DART AEROSPACE LTD	Work Order:	95320
Description: Crosstube Assembly (206L High Fwd)	Part Number:	D206-667-143
Inspection Dwg: D206-667-143 Rev: C		Page 1 of 2

DRAWING NO. D206-667-143	TITLE CROSSTUBE ASS'Y (206L HIGH FWD)	REV. C	DART AEROSPACE LTD ENGINEERING ORDER		D.E.O. NO. D206-667-143-C-1	SHEET NO. SHEET 1 OF 1	SCALE NTS
DRAWN <i>97</i>	CHECKED <i>ASS</i>	MFG. APPR. <i>128</i>	APPROVED <i>MD</i>	DE APPR. <i>MD</i>			
DATE 11.07.15	DATE 11.07.20	DATE 11.07.21	DATE 11/07/21	DATE 11.07.21

REPLACE MAGNOBOND WITH PROSEAL.

ADD ELECTRICAL GROUNDING STRAP

DETAIL P
BONDING STRAP INSTALLATION 2 PL

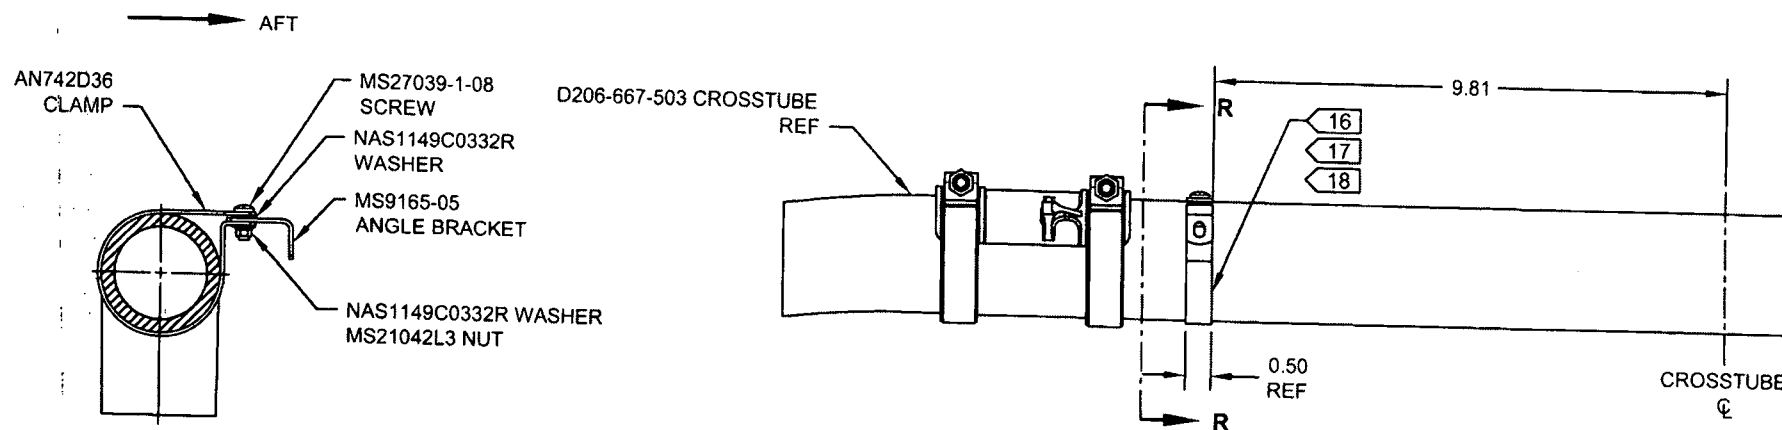
- 16) MASK AREA UNDER CLAMP PRIOR TO PAINTING
- 17) SEAL EDGES WHERE AN742D36 CLAMP MEETS WITH THE CROSSTUBE USING SIKAFLEX-241/-291 OR MIL-S-8802 CLASS B2 OR PROSEAL 890 SEALANT
- 18) PERFORM RESISTANCE CHECK TO ENSURE MAX RESISTANCE IS 10 MILLIOHMS
